I HEREBY CERTIFY THAT THIS STRUCTURE
WAS BUILT ACCORDING TO PLANS EXCEPT
AS NOTED HEREIN
SIGNED: Stanly DATE 4-1-79

PROJECT No. 6.804135
STANLY-MONTGOMERY COUNTY
STATION 58+67.0-L
SHEET 1 OF 2
STATE OF NORTH CAROLINA
STATE HIGHWAY COMMISSION
RALEIGH
GENERAL DRAWING
BRIDGE OVER PEE DEE RIVER
ON NC 24/27
BETWEEN ADERVAARLE AND TROY

GENERAL DRAWING
BRIDGE OVER PEE DEE RIVER
ON NC 24/27
BETWEEN ABERNATHY AND TOLSON

SUPERSTRUCTURE
PLAN OF SPAN A AND
ORDER OF POURING

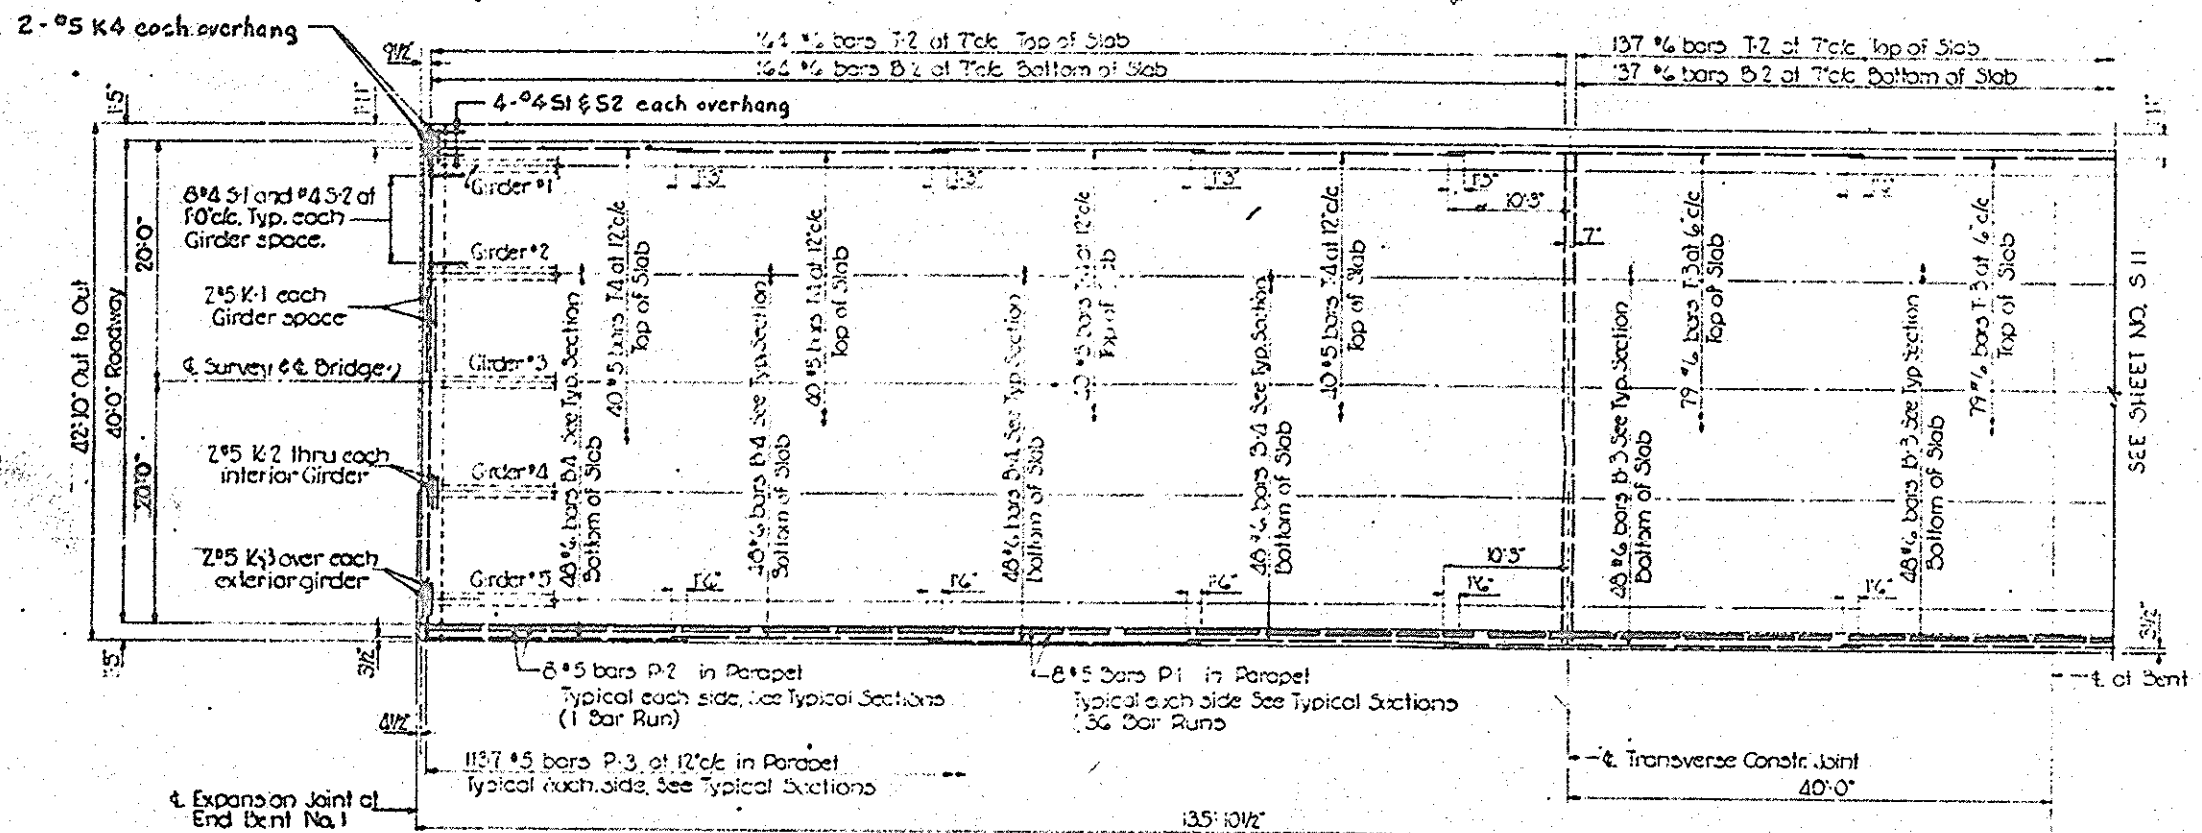
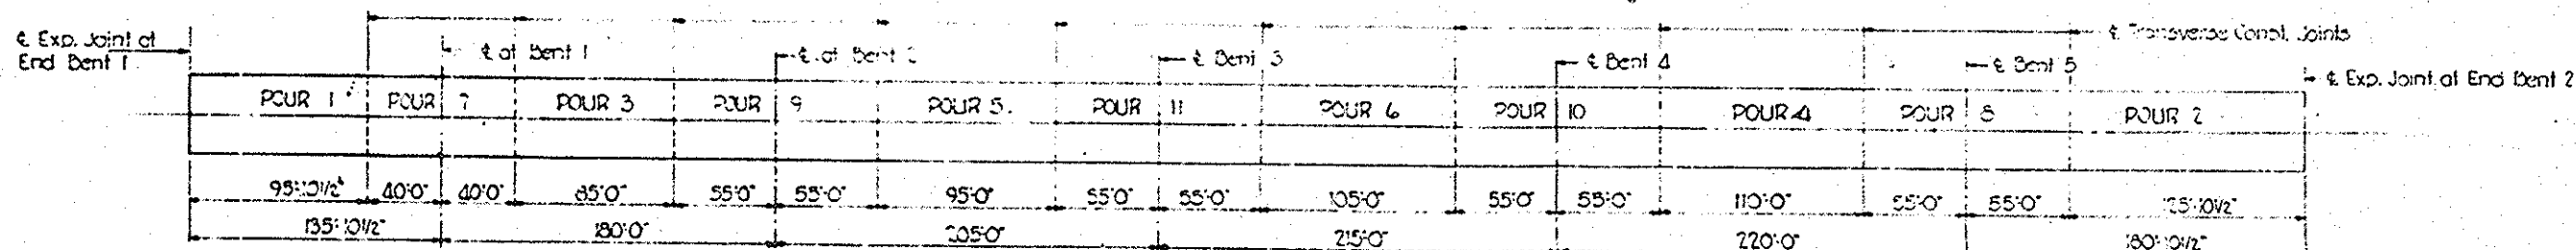
Rev. #1 - Revised to accommodate Exp. Jt. Seal as submitted by the contractor by J.C.C. by A.R.S.

Rev. #1 Revised to accommodate Exp. Jt. Seal as submitted by the contractor by J.C.C. ✓ by A.R.S

STATE OF NORTH CAROLINA STATE HIGHWAY COMMISSION RALEIGH					
SUPERSTRUCTURE DETAILS					
CROSS FRAMES AND BOTTOM CHORD BRAC					
REVISIONS					
NO.	BY	DATE	NO.	BY	DATE
1			3		
2			4

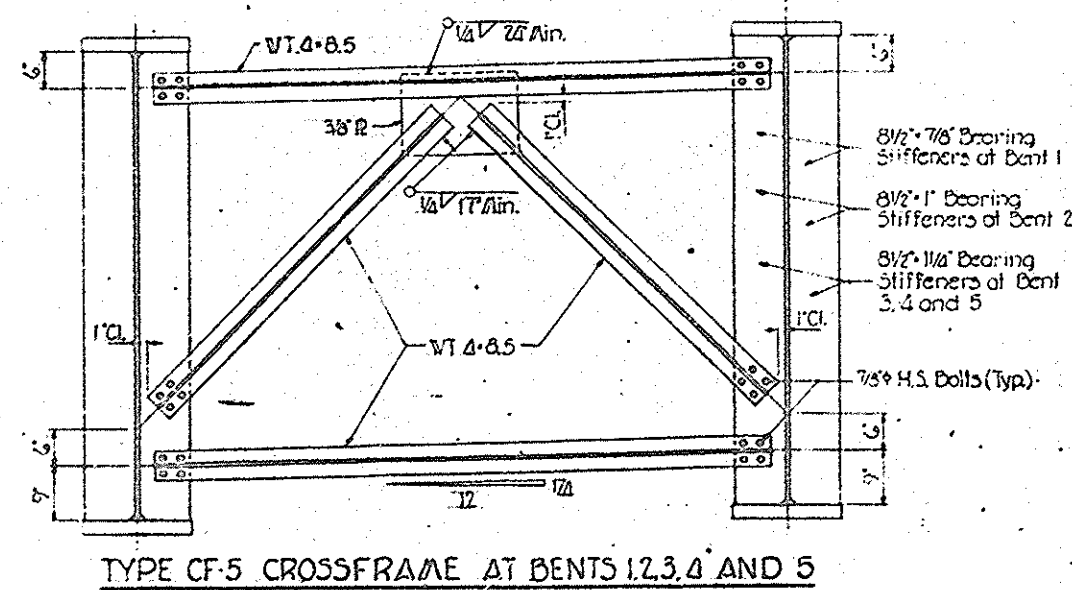
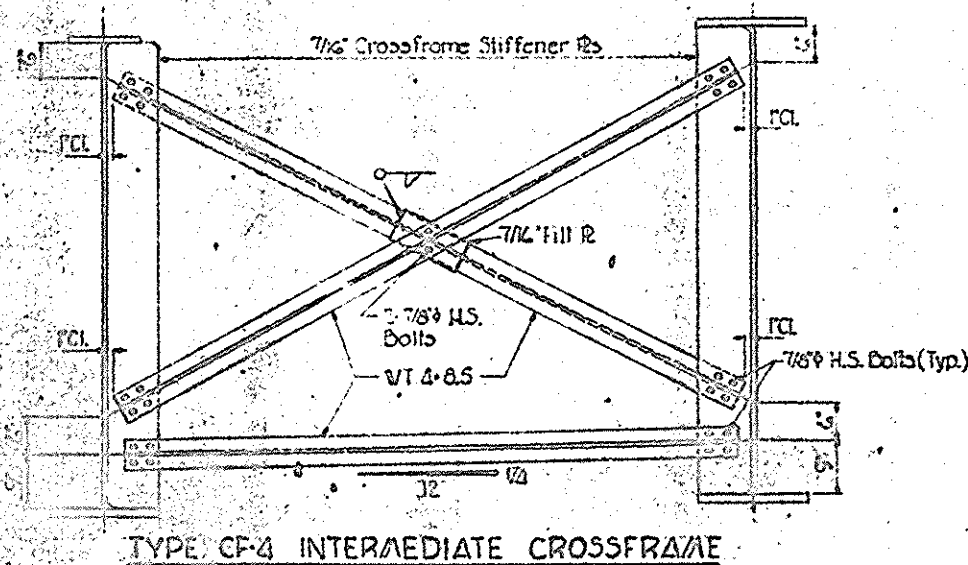
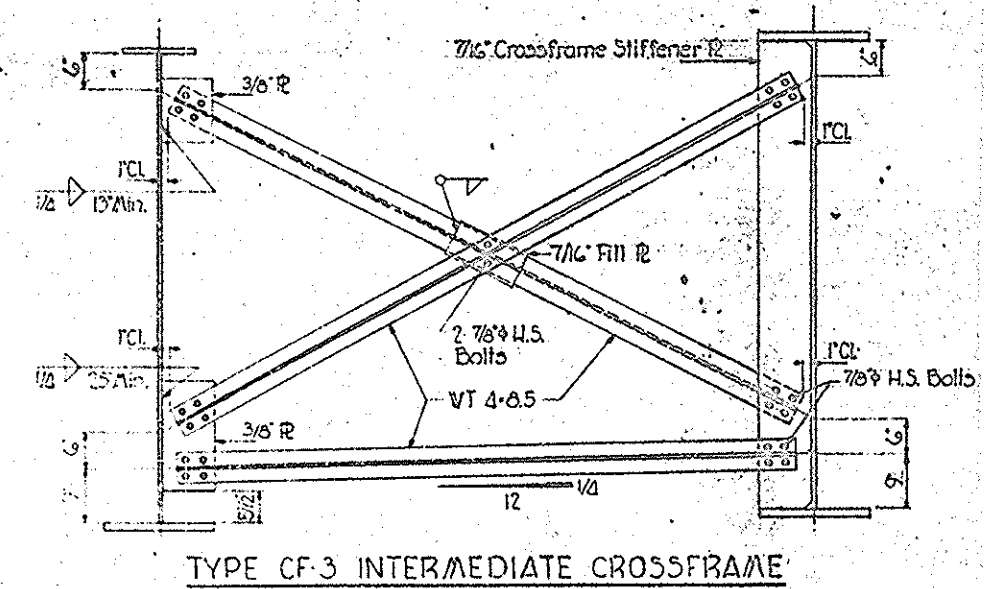
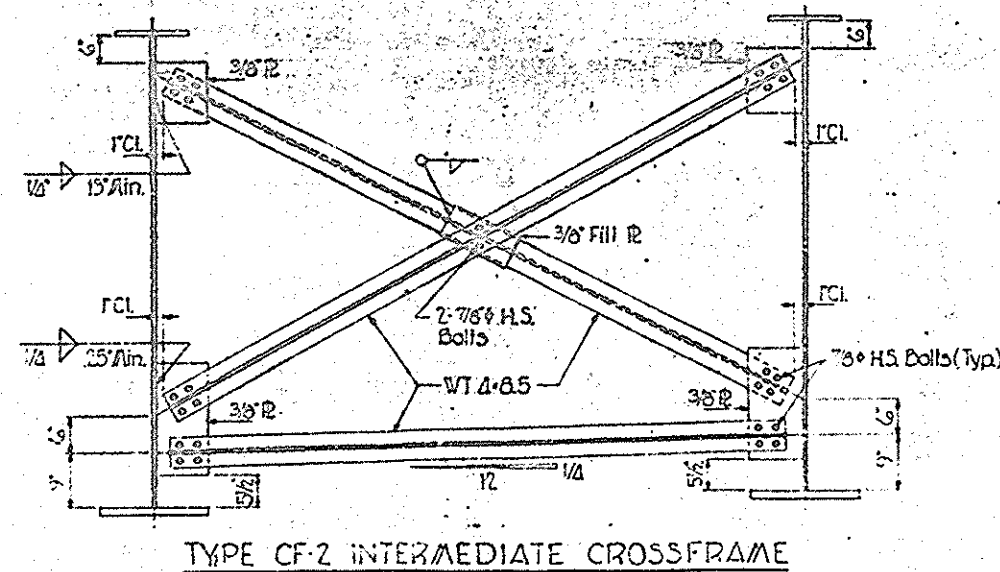
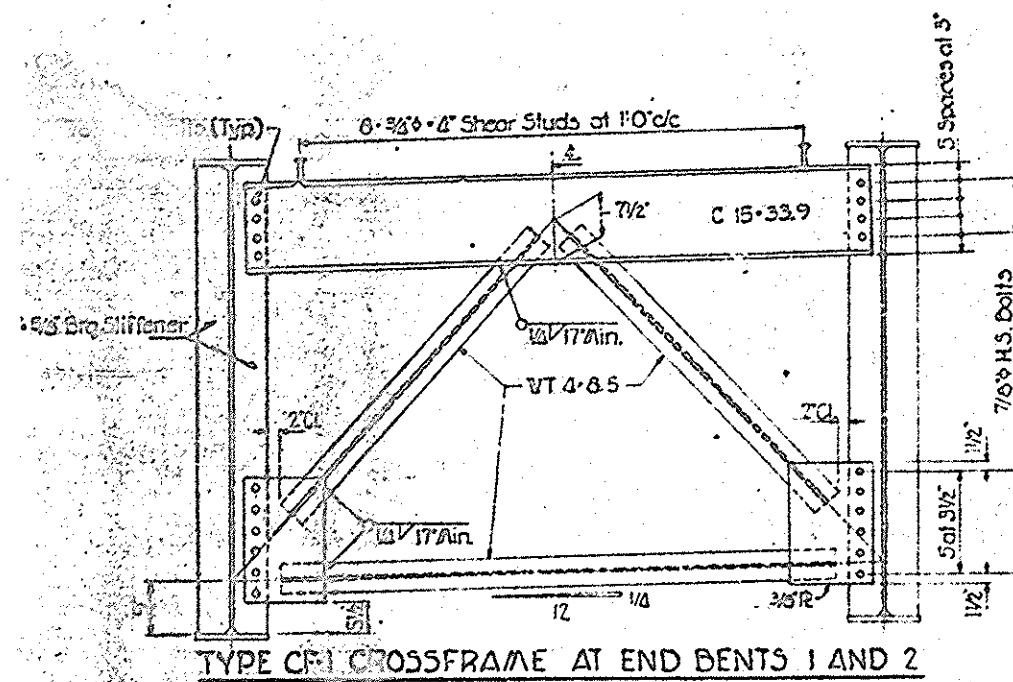
Rev. 11: Revised to add 2-WT4-8.5 Bottom Chord Laterals
Indicated 10. By NCS. VB, SEP. 11/22/1976

ALTERNATE EXPANSION BEARING ASSEMBLY (EB-2 AND EB-3)

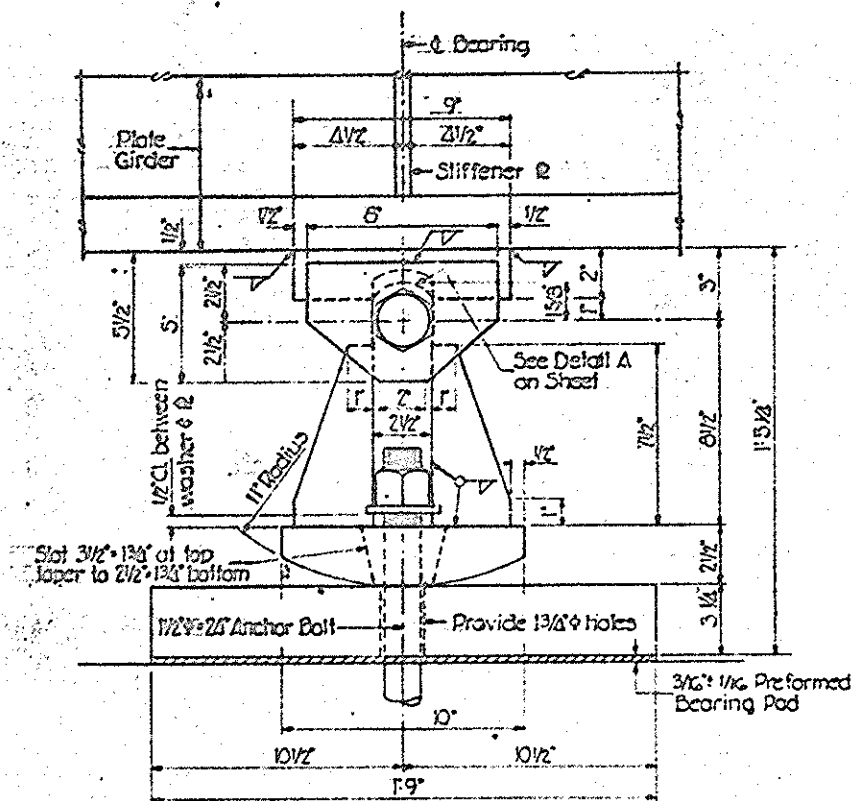
Revised: Revised to change length of C.S. pipe from 1'-6" to 1'-9". 7-7-76 NCS

SUBSTRUCTURE
END BENT 1

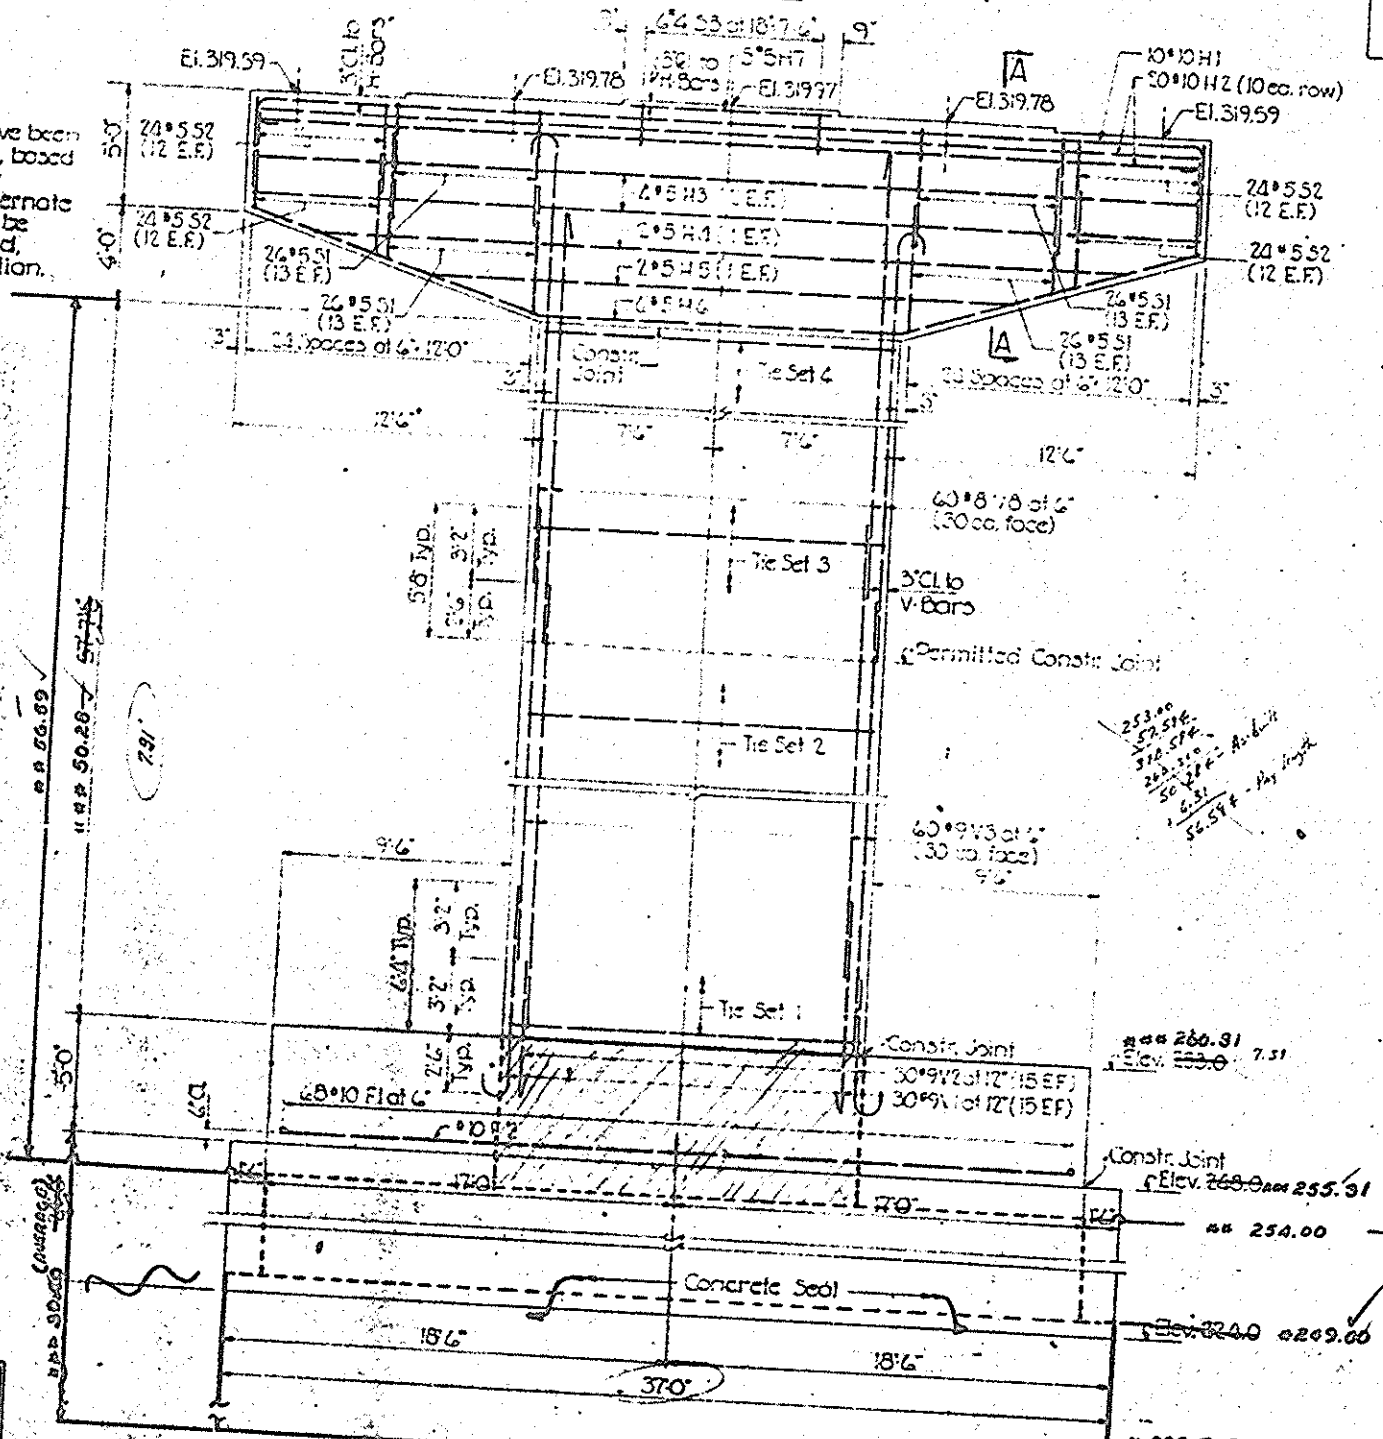
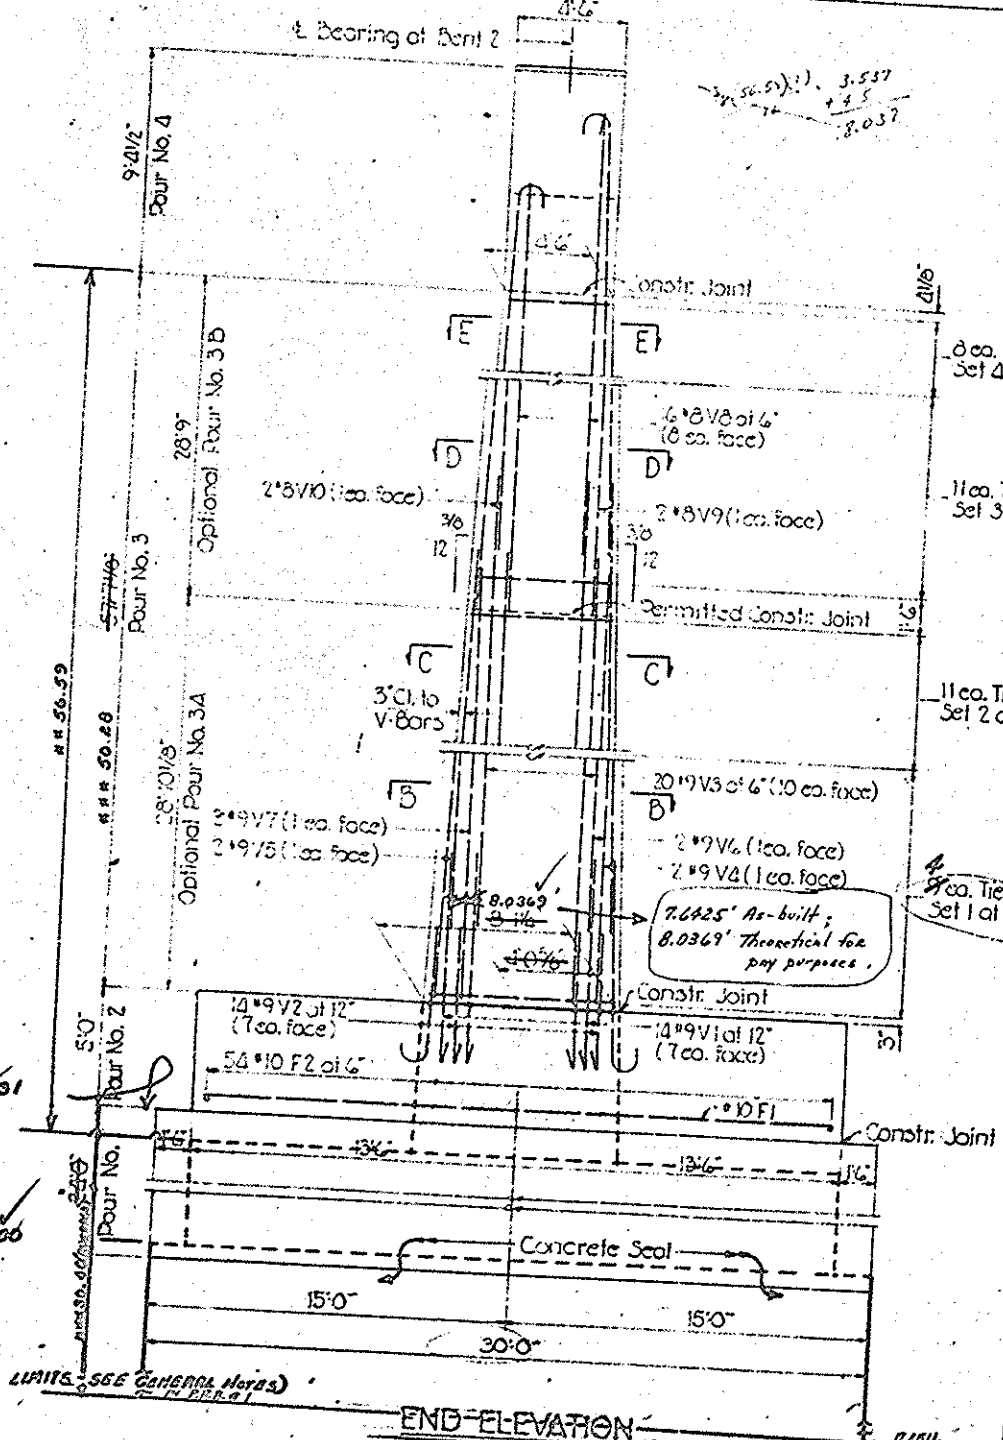
Rev. #1 - Revised to accommodate Exp. Jt. Seal as submitted by the contractor by J.C.C. & by A.R.S.

* SEE STR. PAY RECORD BOOK #1, P. 8 for explanation of changes.

FOOTING PLAN

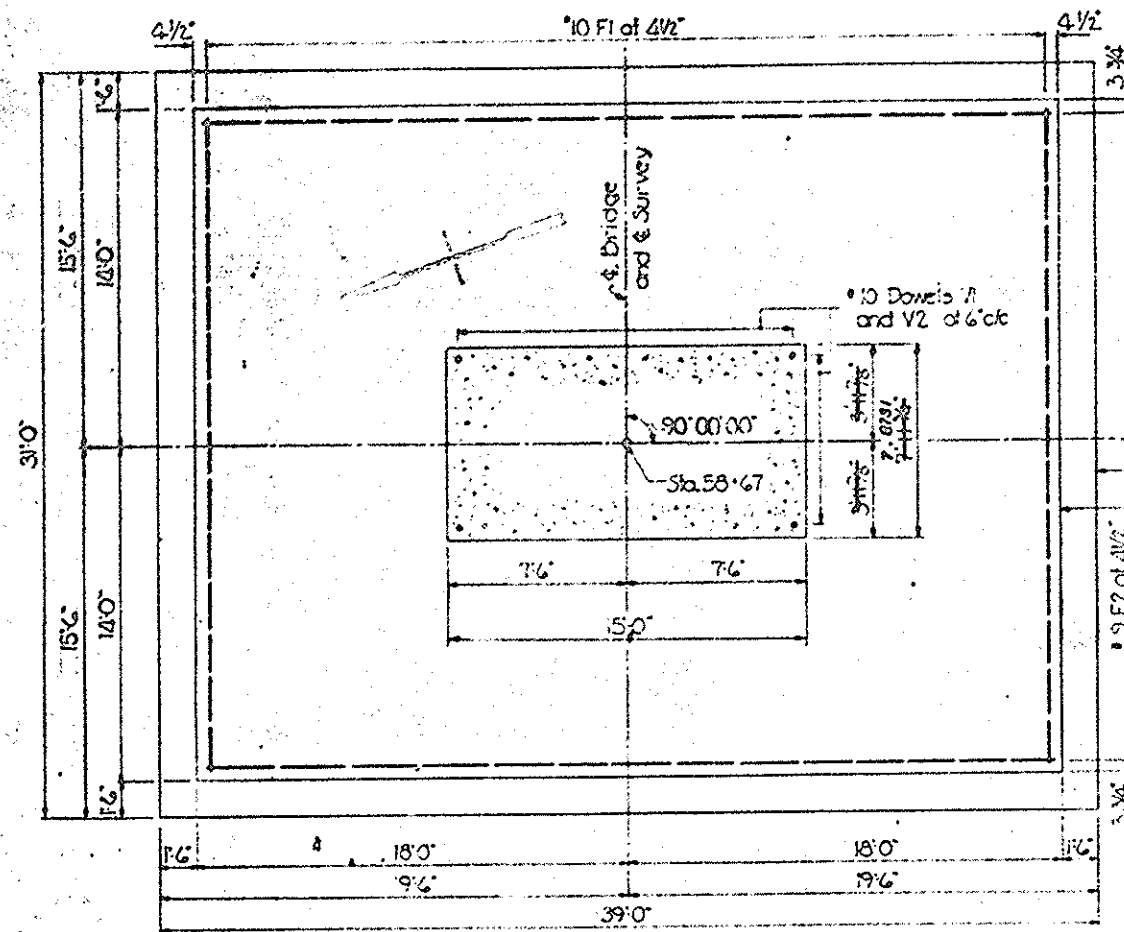
± DDJ. Top of Seal
± ± RS. Built
